## Re: Defect Information Report FL-529, M2 High Current Tail lamp PDM

## Defect Information Report (Section 573.6)

Fig. 1. High-Amp Taillight PDM Installation

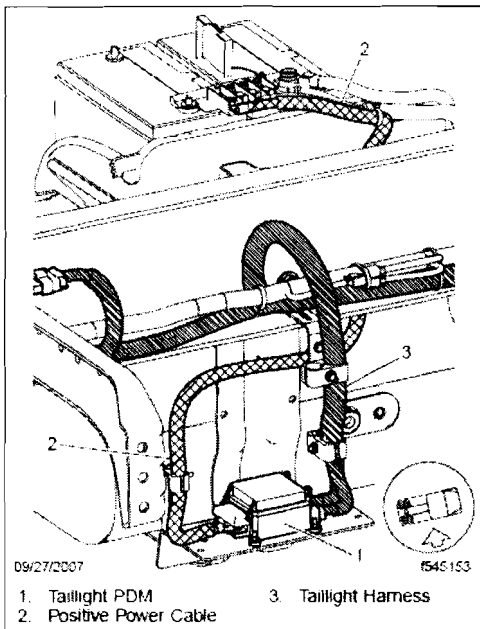
**Basis for determining population:** Option Code 294-1AE – High Current Tail Lamps  
Chassis Mounted PDM (Power Distribution Module) mounted inboard and low on a bracket  
off the fuel tank.

(c)(5) **Description of the defect:** The optional High Current Tail lamp PDM (Power Distribution Module) was installed in a location highly susceptible to water intrusion. This may lead to a loss of rear lighting.

**(c)(8) (i) Remedial program:** The PDM will be relocated to inside the cab behind the driver's seat. Repairs will be performed by Daimler Trucks North America dealerships and Direct Warranty customers, i.e., customers approved by Daimler Trucks North America to do their own warranty repairs.
